Technical Service Bulletin

26 Noises are heard from the exhaust at idle, DTCs P047600, P048C00, P04A000, or P301B00 are stored in the ECM

26 21 45 2058998/3 May 18, 2021. Supersedes Technical Service Bulletin Group 26 number 21-44 dated February 1, 2021 for reasons listed below.

Figure 2. Old rear silencer.

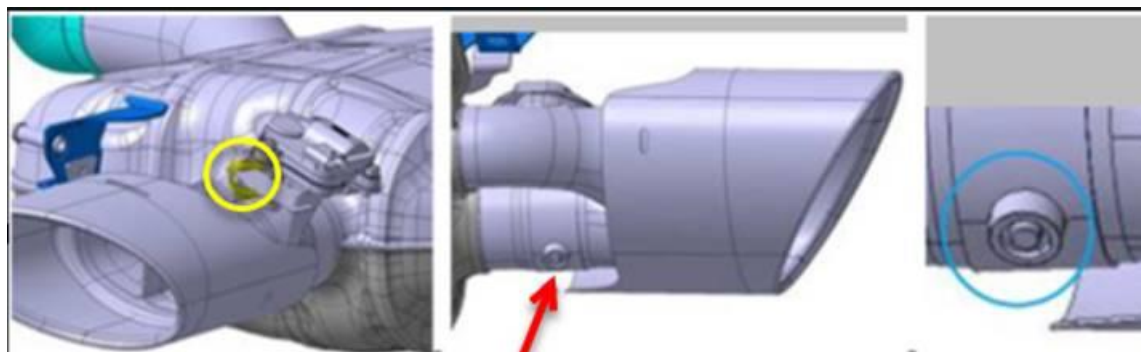
- A. Old version (Figure 2): C-bracket (marked yellow) and moveable bearing (blue). **It is not compatible with an optimized control motor.** The complete rear silencer has to be replaced.

Figure 3. The optimized version of the rear silencer.

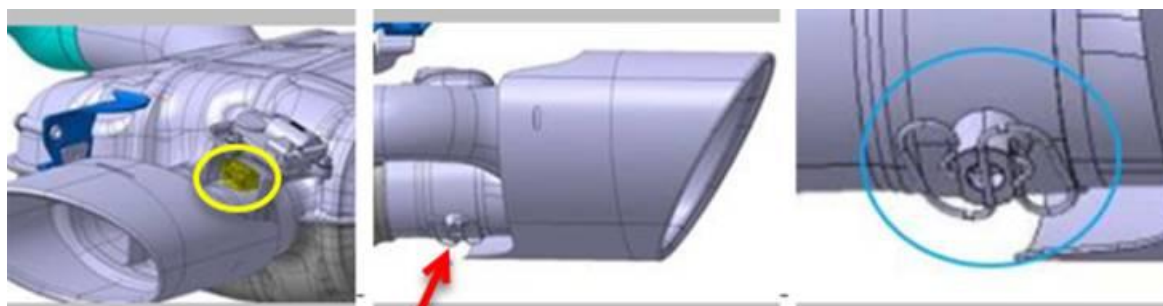
- B. Optimized version (Figure 3): claw coupling (marked yellow) with spring lock (blue). Check which version of the control motor is fitted: If the control motor fitted is not the new version (part number 8S0 133 246 D), replace it individually on the exhaust flap with the concern.
